UNITED STATES PATENT AND TRADEMARK OFFICE

APPLICATION NO.	FILING DATE	FIRST NAMED INVENTOR	ATTORNEY DOCKET NO.	CONFIRMATION NO.
10/628,171	07/28/2003	Annette C. Grot	10004269-1	5594

Office Action Summary	Application No. 10/628,171	Applicant(s) GROT ET AL.	
	Examiner Jennifer Doan	Art Unit 2874

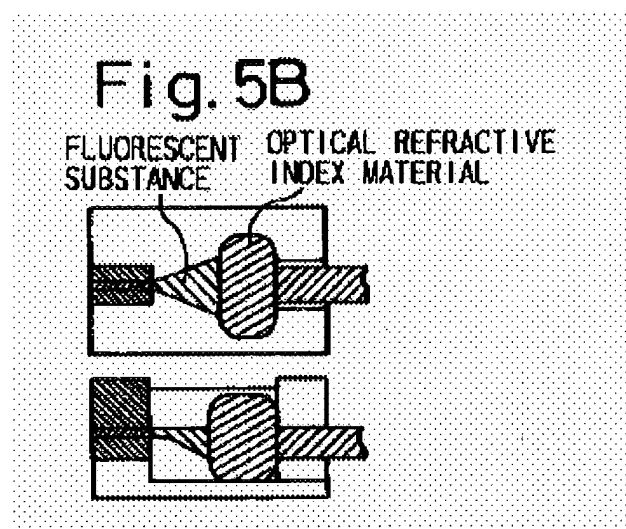
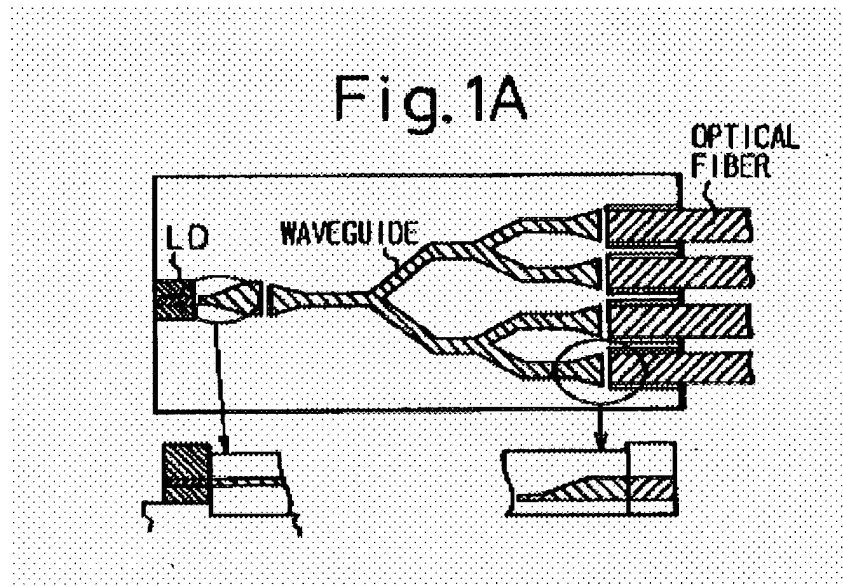
With respect to claims 1, 2 and 11, Yoshimura et al. (figures 1A, 5A and 5B) disclose a method and an apparatus of an optical waveguide device comprising a first optical waveguide having a first end (see figure 1A); a second optical waveguide having a first end, the first ends of the waveguides being separated by a gap (figure 1A); and an optical coupler extending across the gap between the first ends of the waveguides, the optical coupler comprising material including a waveguide region, the waveguide region having a shape defined by overlapping cones of light emitted from the first ends of the optical waveguides into the material (figure 5B and column 5, lines 34-42); wherein the material has a refractive index capable of being increased by exposing the material to light of a particular wavelength or wavelength band (column 3, lines 62-66).

With respect to claims 3 and 15, Yoshimura et al. (figure 5B) disclose a method and an apparatus of an optical waveguide device, wherein exposing the material to the light of a particular wavelength or wavelength band causes the material to undergo cross-linking.
